# **FINAL ENVIRONMENTAL IMPACT REPORT**

## ***Il Villaggio Toscano Project***

**ENV-2004-6000-EIR**

**January 2013**

**Figure II-1**  
Refined Conceptual Site Plan

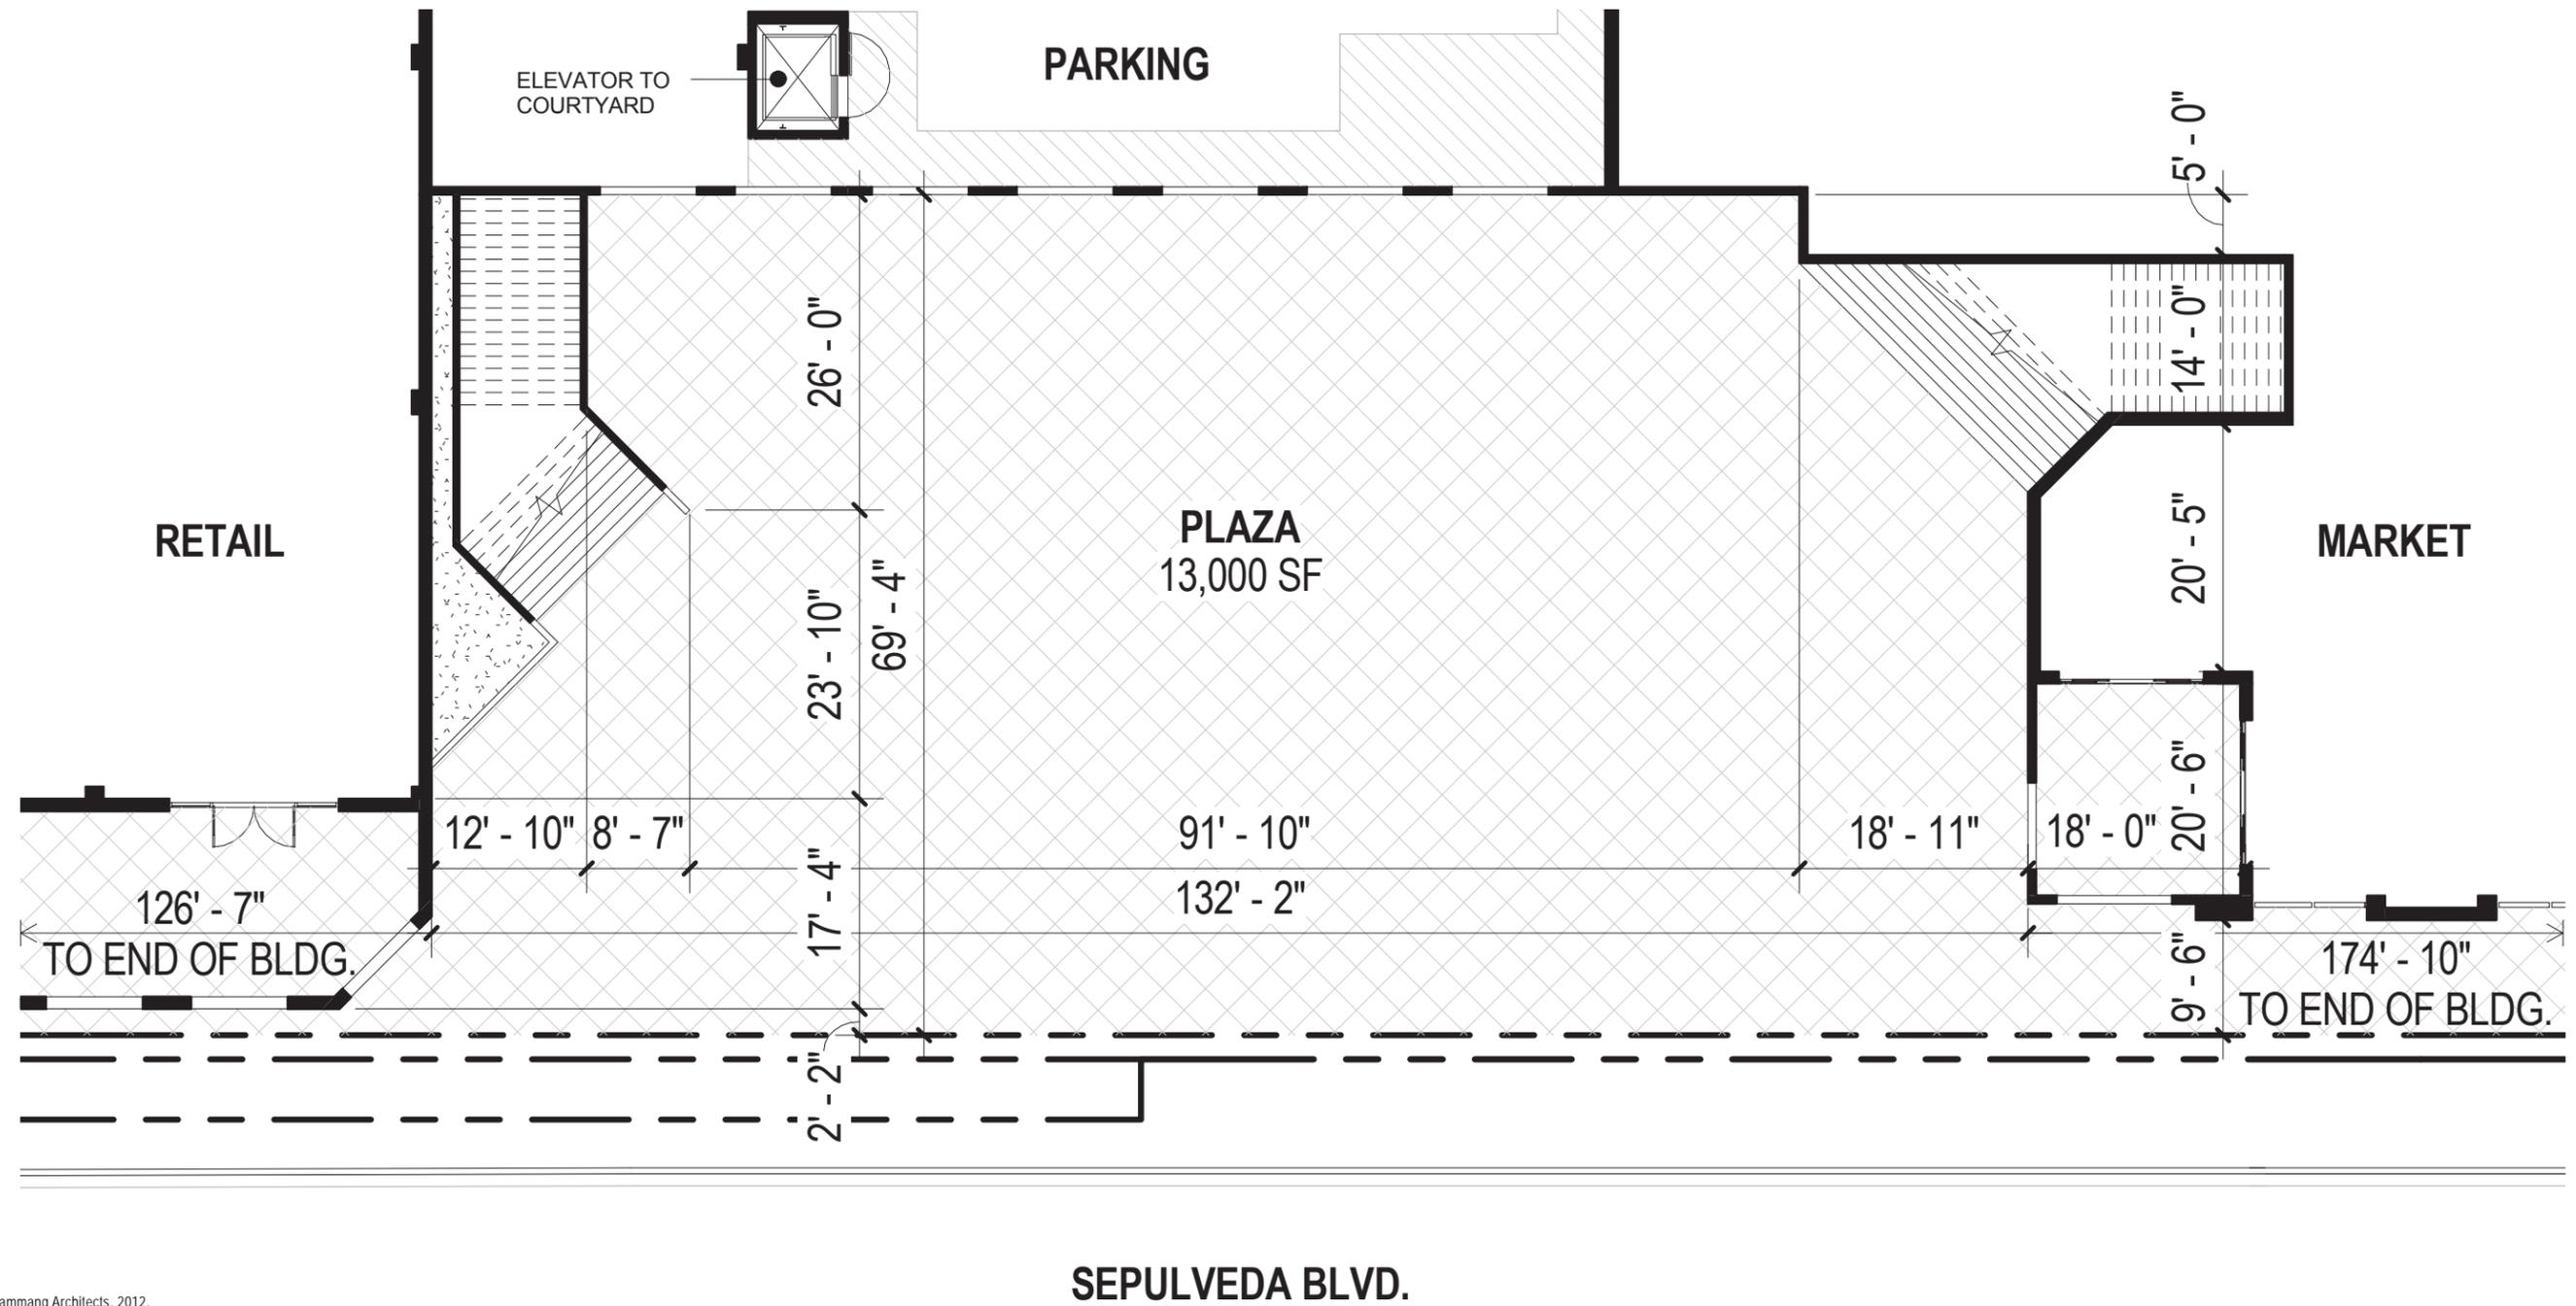
The number of residential units proposed by the Applicant has been reduced from 500 to 399 residential units. The refined layout of the Project Site is illustrated in Figure II-1 on page II-2. As shown in Figure II-2 on page II-3, the publically accessible plaza along Sepulveda Boulevard has been expanded. To accommodate an expanded publicly accessible plaza, the proposed project's 55,000 square feet of neighborhood serving retail uses has been reduced by 3,000 square feet to 52,000 square feet of retail uses. Furthermore, the building heights along Sepulveda Boulevard have been reduced based on their distance from the Sepulveda Boulevard property line. Specifically, buildings located within zero to 45 feet from Sepulveda Boulevard would be a maximum of four stories (two stories above the podium), buildings located within 45 feet to 125 feet from Sepulveda Boulevard would be a maximum of six stories (four stories above the podium), and buildings located more than 125 feet from Sepulveda Boulevard would be a maximum of eight stories. Please refer to Figure II-3 through Figure II-5 on pages II-4 to II-6 that illustrate the updated conceptual elevations for the proposed project with the proposed design modifications.

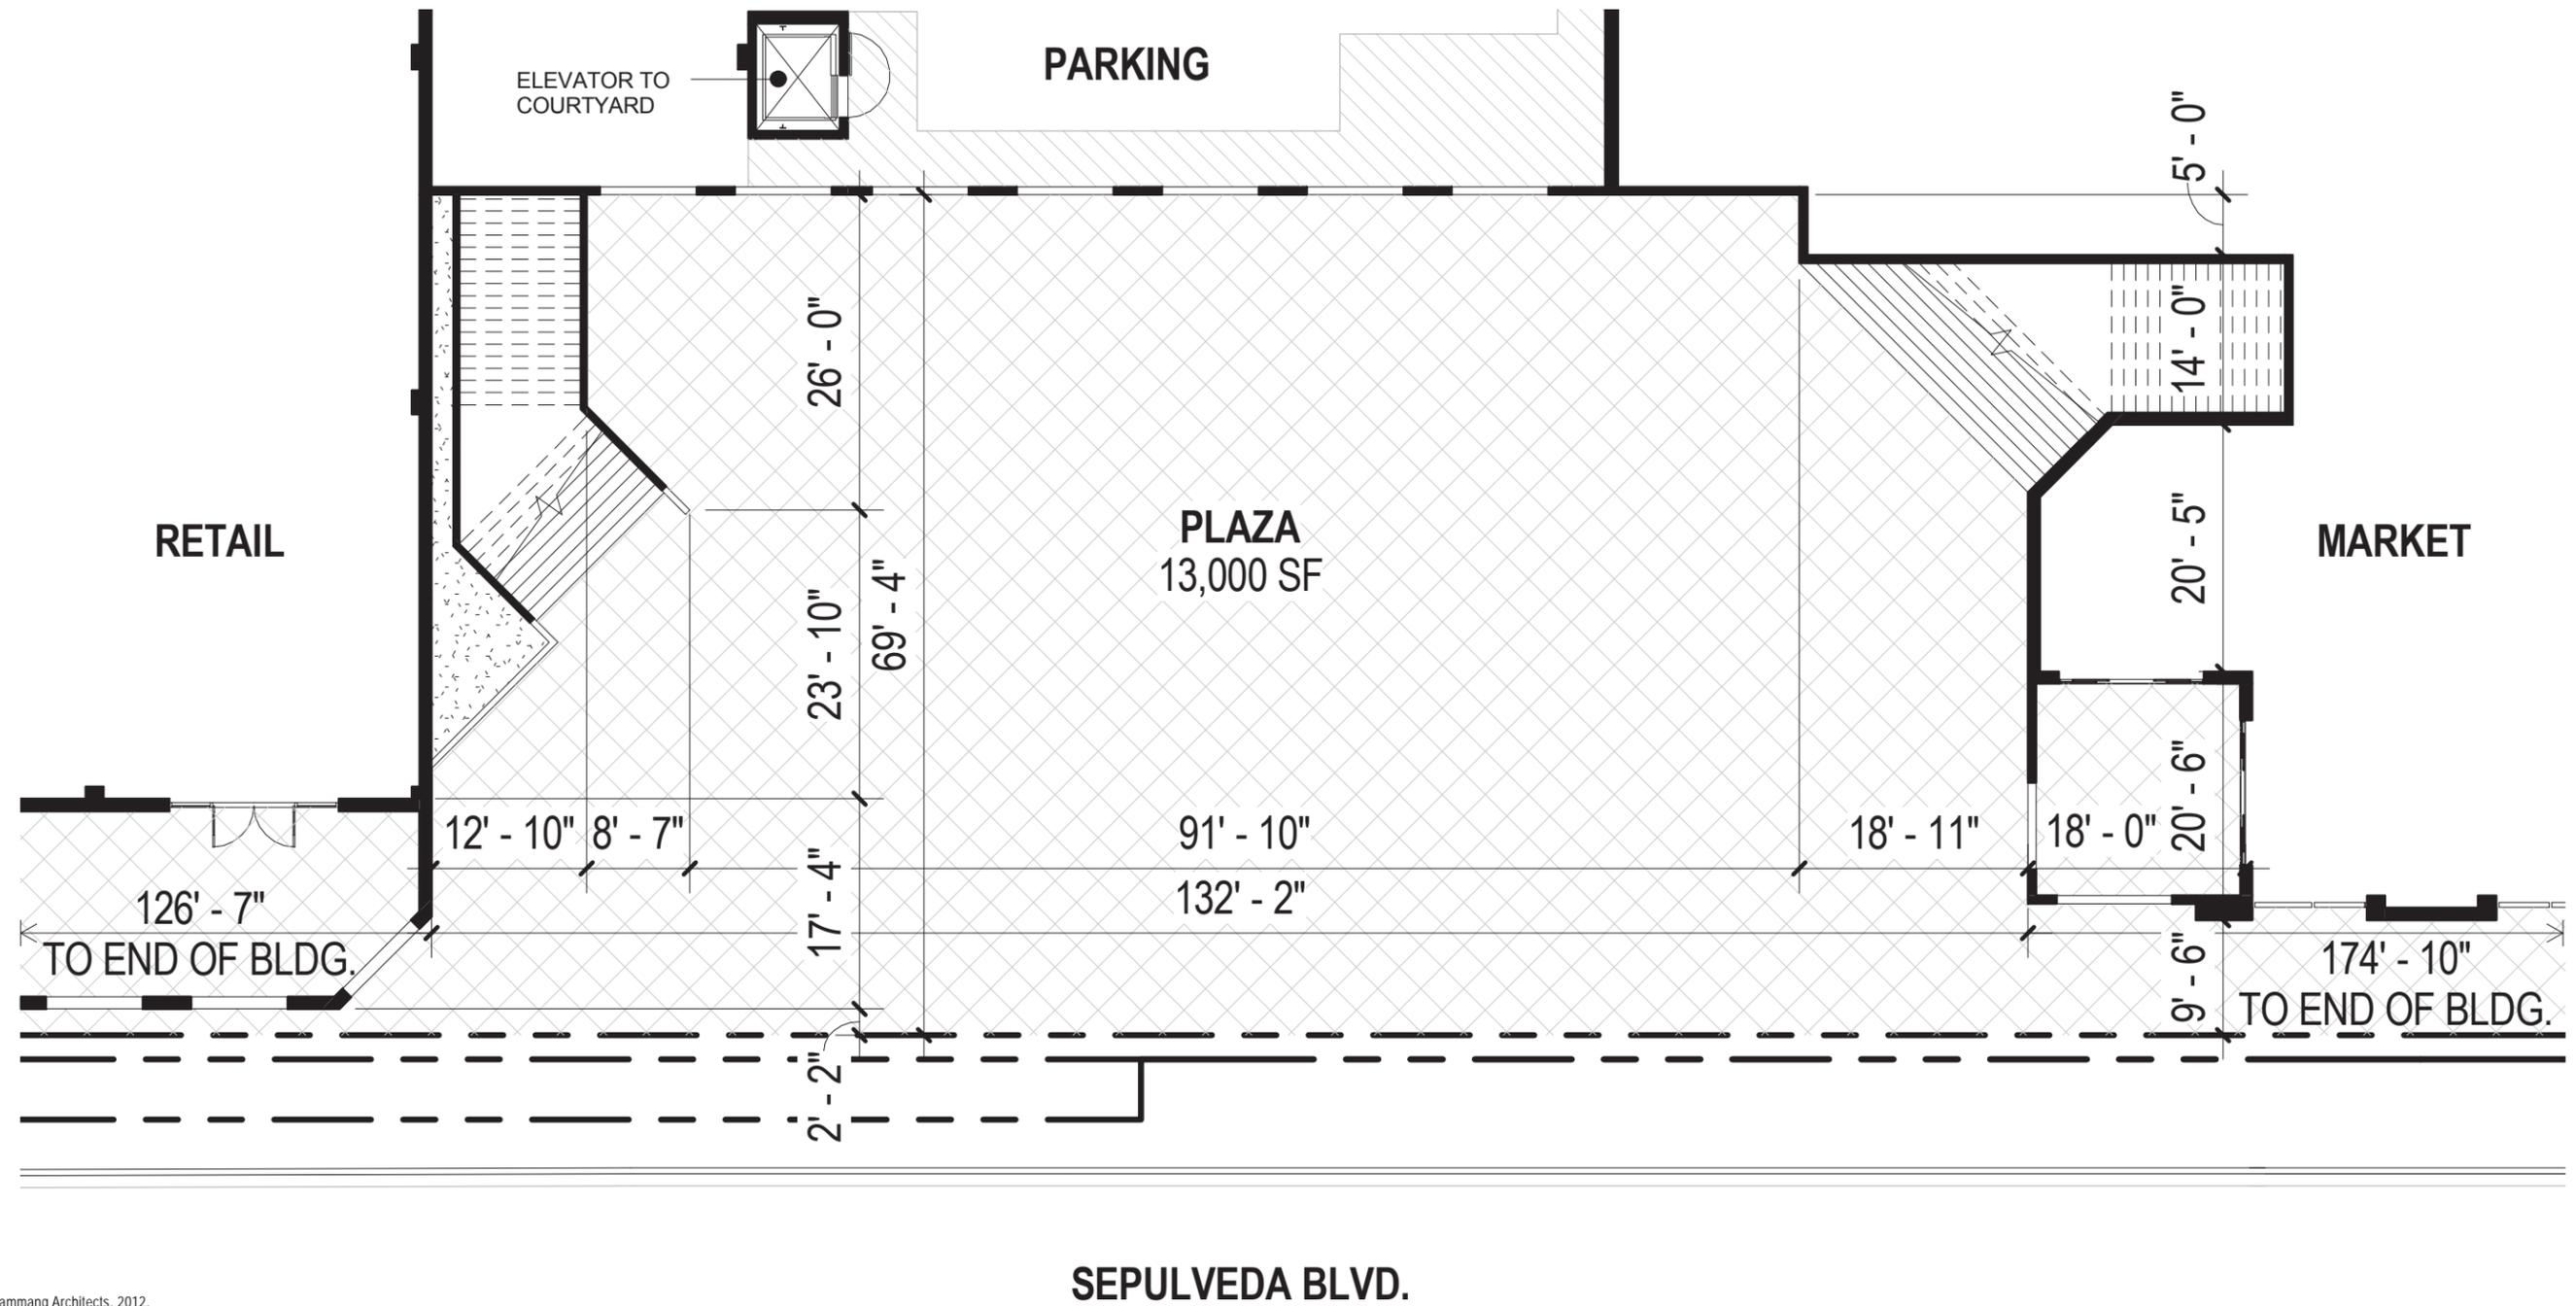
Volume 1, Section IV.L.1, Utilities—Water Supply, page IV.L-24, Figure IV.L-1 revise figure as shown on page II-43:

Figure IV.L-1 in Section IV.L.1 of the Draft EIR and Exhibit 2 of Appendix J of the Draft EIR have been revised with the revisions requested. Please refer to Section II, Corrections and Additions, of this Final EIR.
